**An operational safety case for Hunterston B R3 to a core burn-up of 16.425TWd
following the 2018 graphite core inspection outage
NP/SC 7766: Stage Submission 1**

Graphite structural integrity assessment

Assessment Report ONR-OFD-AR-19-053
Revision 0
August 2020

Figure 1: Examples of fragment movement with core age (HNB R3)

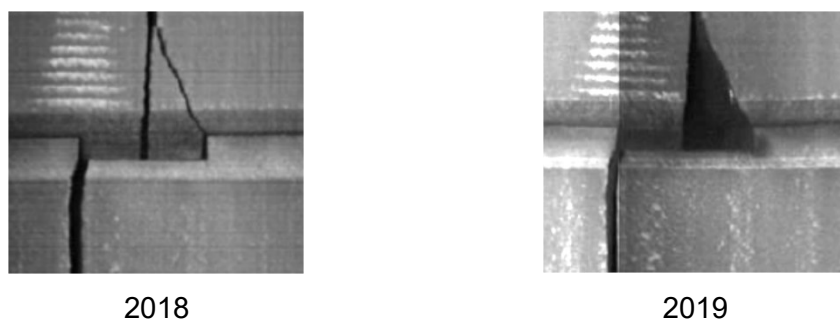
- 82 Debris migration: NGL's review of graphite debris (Reference 27) does not significantly add to the existing arguments for the likelihood of graphite debris migration, and this is unsurprising given the subjective nature. It is important then to recognise the inherent weakness in arguments for the likelihood of graphite debris migrating to safety significant locations, and that emphasis should be placed more on the consequences and debris production arguments.

Figure 3: Distribution of the utilisation of the integral key capacity, Reference 14.
 (Utilisations greater than 1 equate to keys that are overloaded.)
 (Core state C = intermediate core state, core state D = CEDTL.)

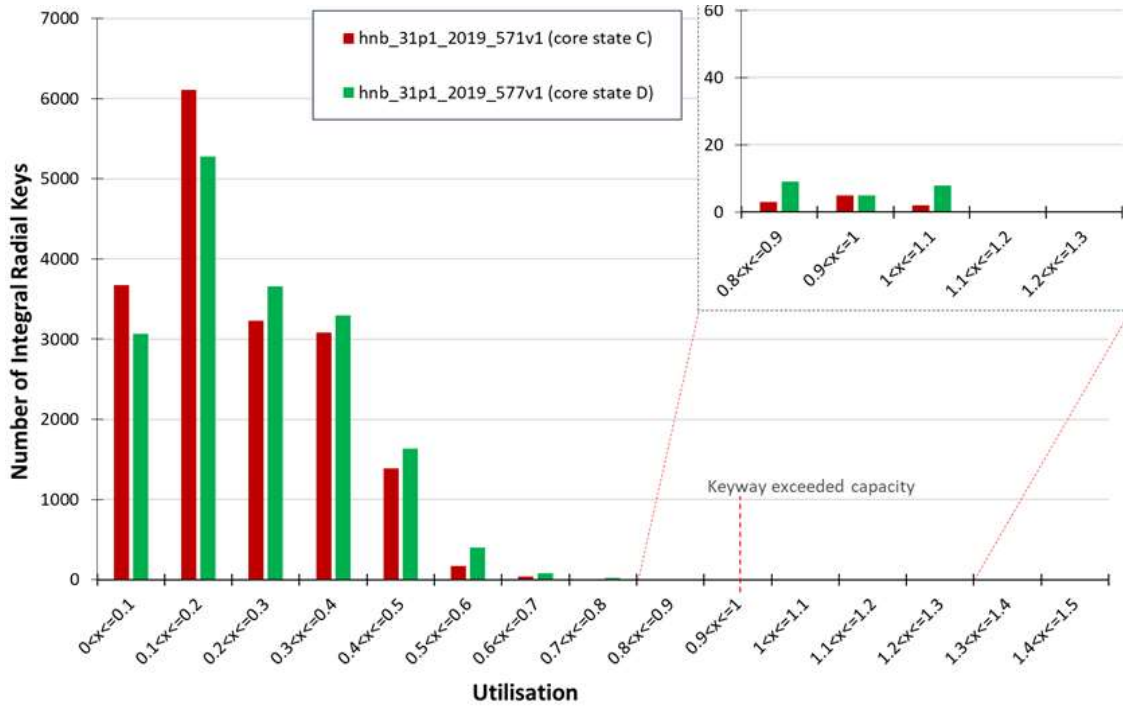
144 In figures 3 and 4 NGL show that the high utilisations are part of a long and shallow tail. This is because the seismic event causes the highest loaded keys/keyways to cluster in particular locations in the core, to increase the size of those clusters needs a substantially more severe seismic event or a substantial reduction in the key/keyway load bearing capacity. Subsequently there is a long shallow tail, and that indicates a

degree of insensitivity to the DTA capacity value. For instance, figure 3 shows the integral key/keyway DTA capacity value would need to be reduced by 20-30% for there to be a sizeable increase in the number of overloaded integral key/keyways. Similarly, figure 4 indicates the loose key/keyway DTA capacity would need to be reduced by 10% before there was a sizeable change in the number of overloaded loose keys.
